# PERMIT

SEWAGE DISPOSAL SYSTEM

HOWARD COUNTY  
BUREAU OF ENVIRONMENTAL HEALTH  
461-9933

SUBDIVISION Glenwood Springs ROAD 2805 Shadow Roll Ct LOT 24

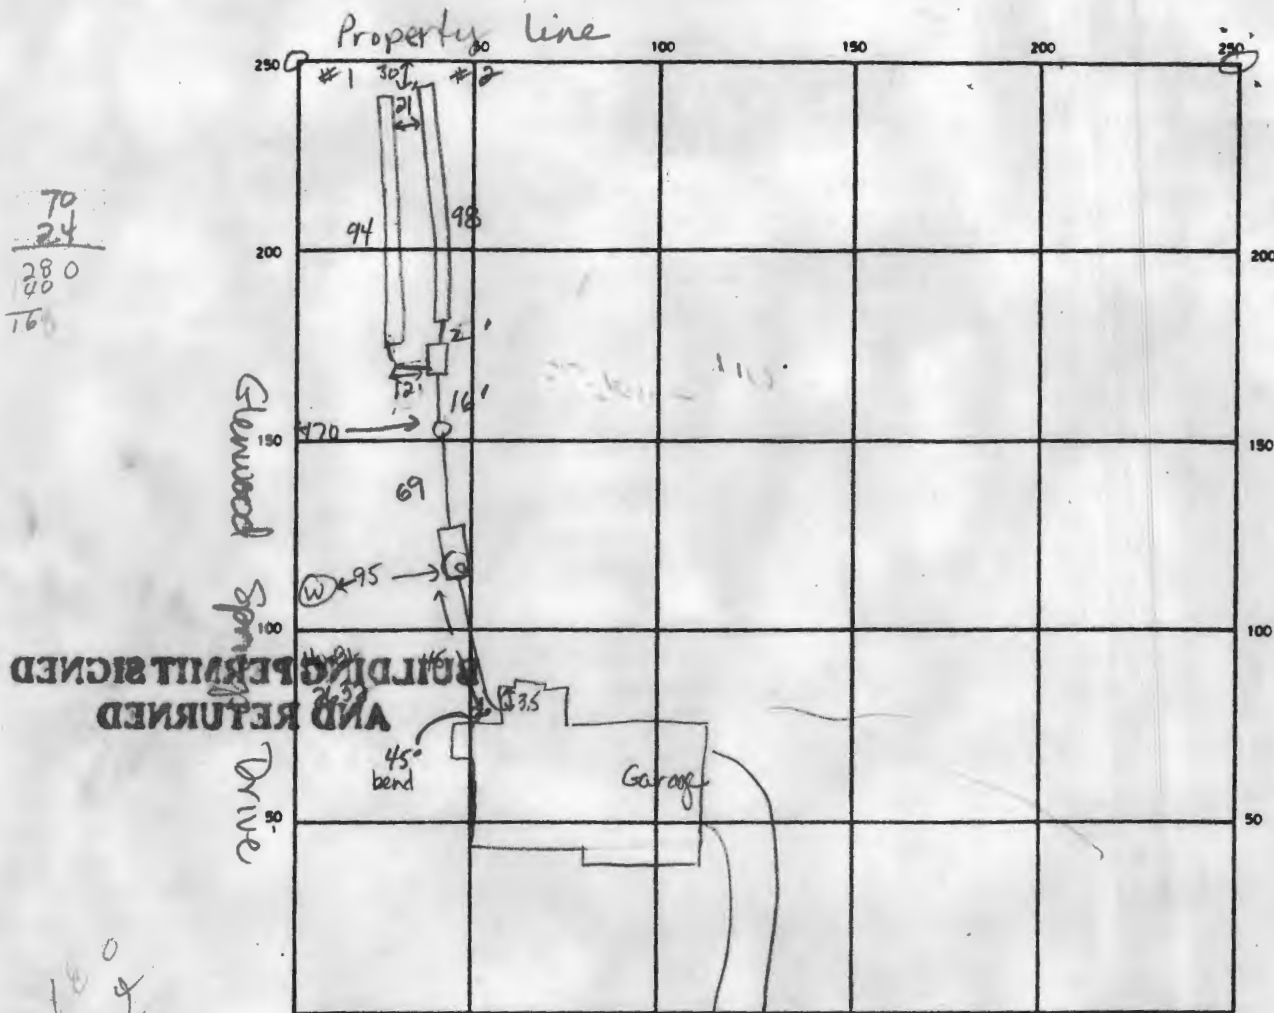
Manhole Needed

SEPTIC TANK. LEVEL 1500 gal

CLEANOUTS one on S Tank (4' below grade)

DISTRIBUTION BOX. LEVEL OK Needs baffle

REMARKS 4-5-89 OK to add stone, pipe & paper to trenches leaving both ends open. septic tank is 4 ft below grade. Must place manhole cover over tank unless grade is reduced. Do Not final until resolved. OK to cover around septic tank and lines to house and distribution box once cemented at tank JEN

4/6/89-COVER SYSTEM BUT INSTALL MANHOLE ON TANK & CALL FOR INSPECTION RIT

MANHOLE CLEANOUT CONFIRMED BY DWABE 5/31/89 C.W.
